Pedestrian Crossing, Bus Reliability and Pavement Improvements on Gray's Inn Road

Zebra Crossing design (at 5 locations)

We have consulted LCDS Chapter 5, page 14, indicative layout 5/04 reproduced here:

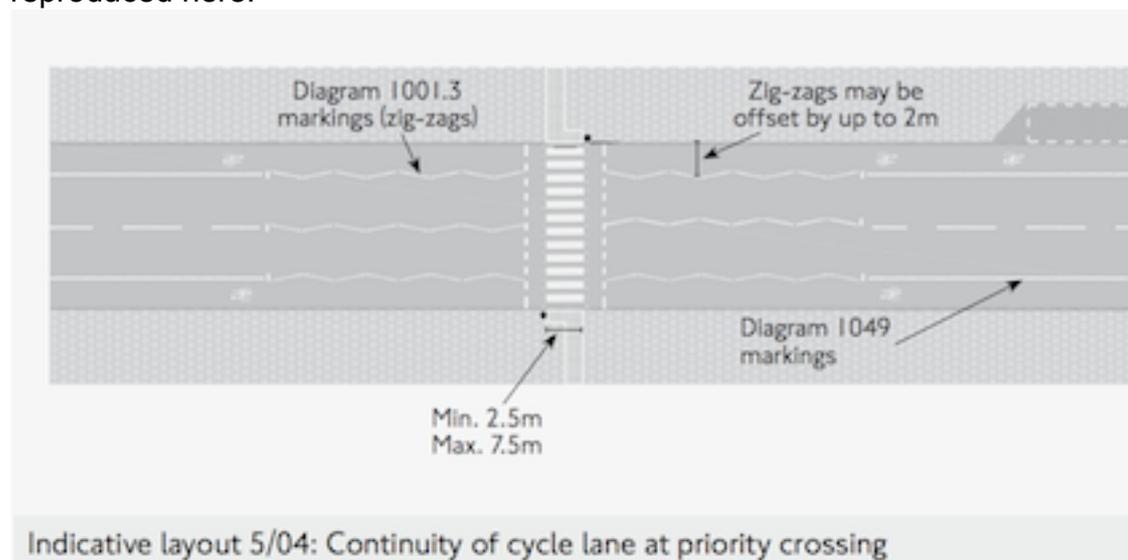
This requires a straight road on the approach to the zebra crossing. The arrangement with a pair of cycle lanes and a pair of motor lanes looks suitable for Grays Inn Road.
